## Design Change of XHW-15C/XHS-15C

Product Name	Applicable Part Numbers
Flexible Couplings Disk Type	XHW-15C/XHS-15C

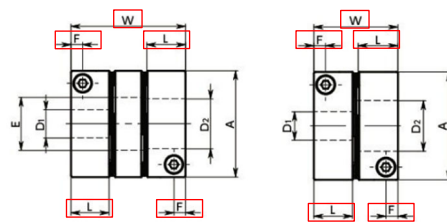
The dimensions will change as follows due to our manufacturing reasons.

Part Number		L	W	F
XHW-15C	Before Change	7.5	21.8	2.1
	<b>After Change</b>	<b>7.8</b>	<b>22.4</b>	<b>2.3</b>
XHS-15C	Before Change	7.5	15.9	2.1
	<b>After Change</b>	<b>7.8</b>	<b>16.5</b>	<b>2.3</b>

Performances such as torque and misalignment and the price will remain the same. Thank you for your understanding of the design changes.
